Product/Process Change Notice (PCN)

PCN #: WL-SUMW_20171215

WL-SUMW 153353xxx all products

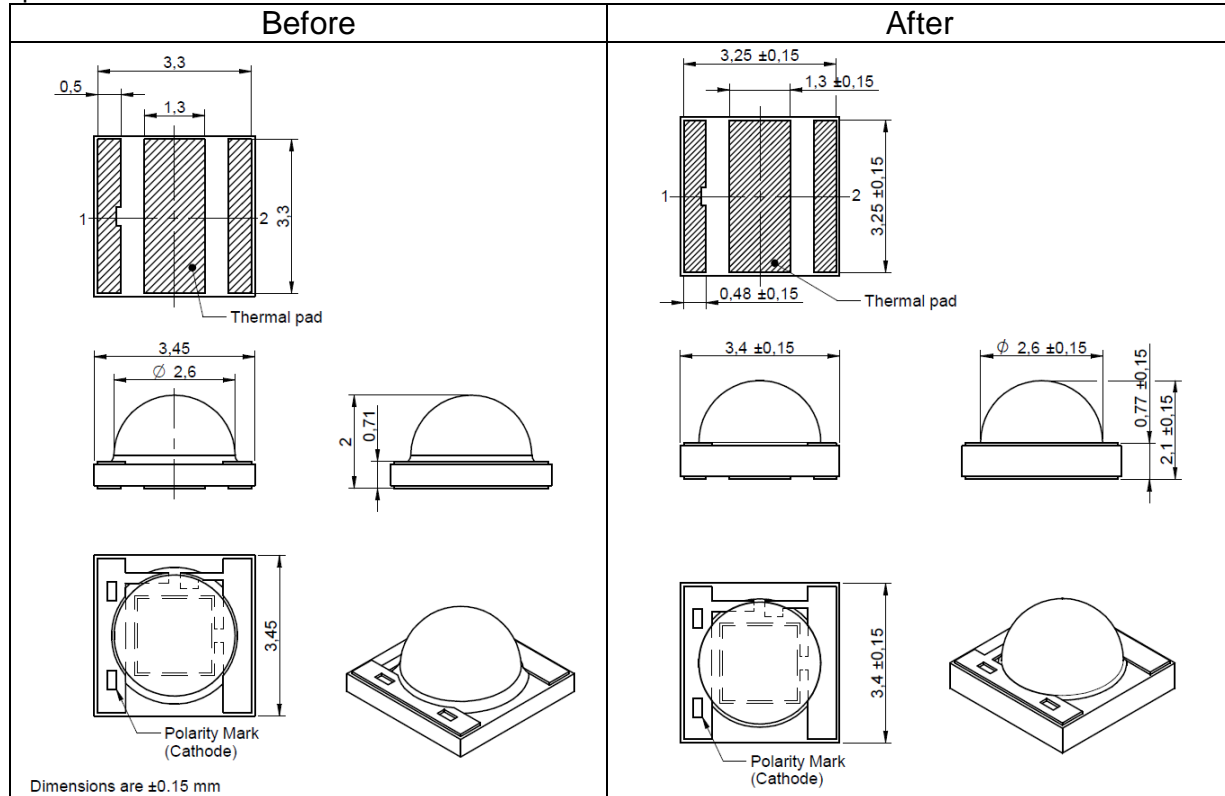
For process improvement purposes, Würth Elektronik will change the dimensions of the substrate for the WL-SUMW line products with 0.05mm

The substrate size will be the only change. The change will not affect the land pattern and soldering specification.
